DR2E Corrections

HF I/Q SDR Receiver DR2E
30 kHz-40 MHz YU1LM/QRP

New corrected PCB new dimensions 112.5 x 67.5 mm

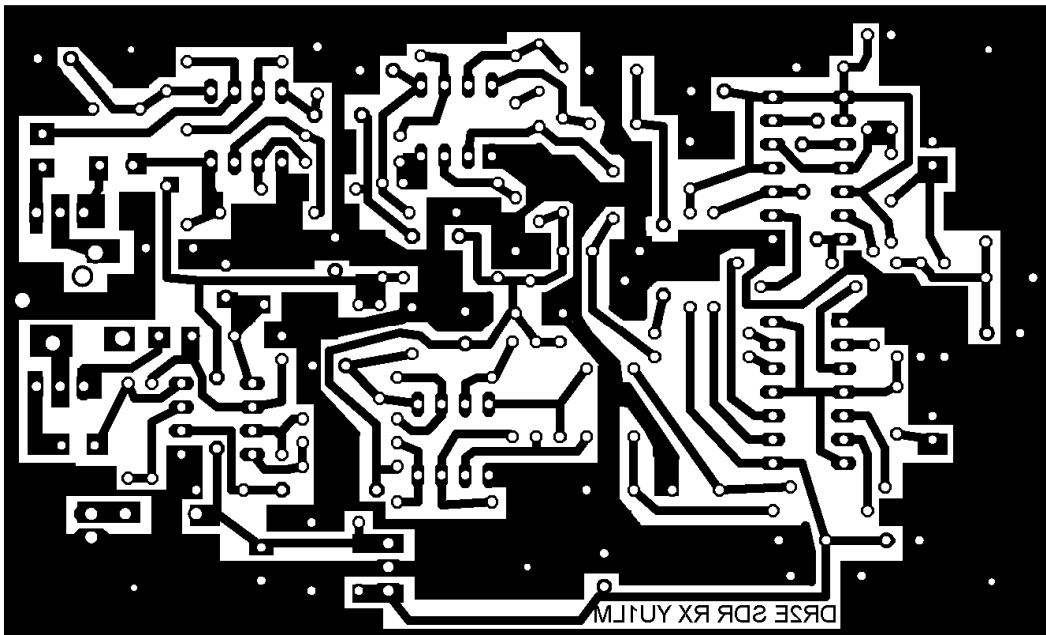
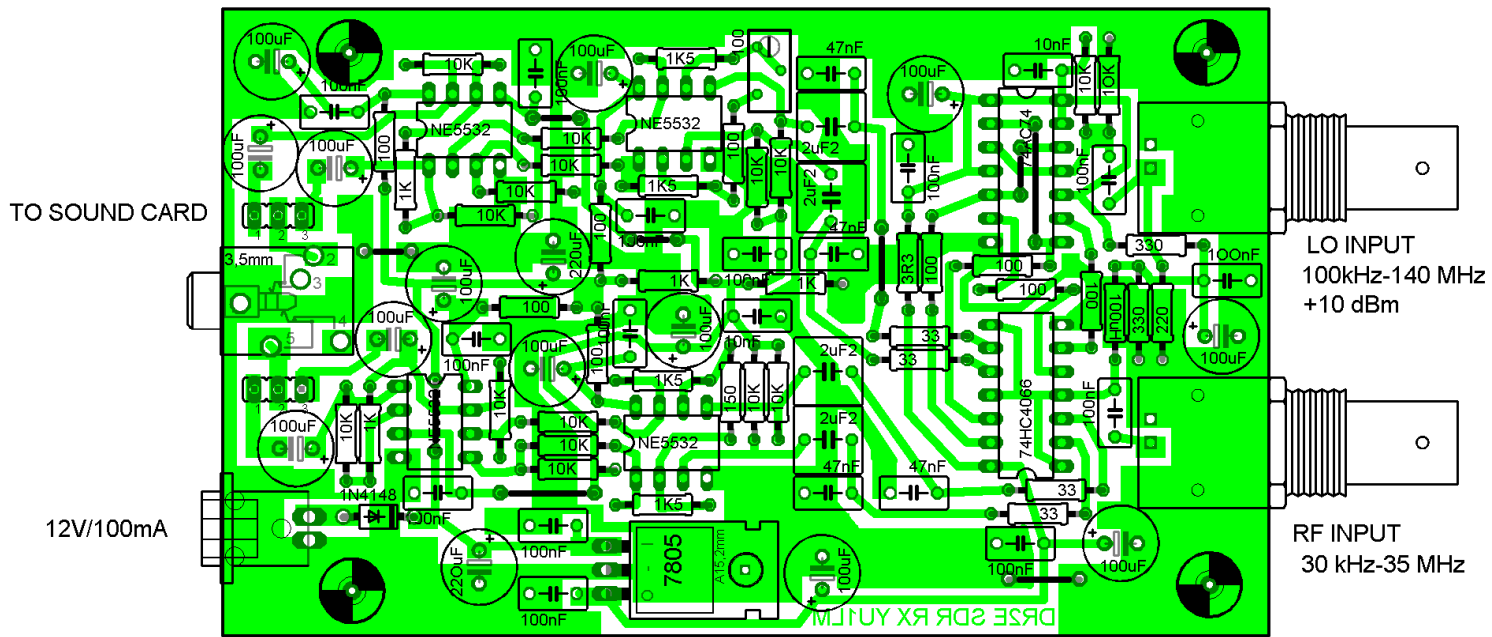
First PCB errors

I missed connection for power supply IC7, IC5 and output C23 100uF. Corrected new version of PCB and Schematic are down.
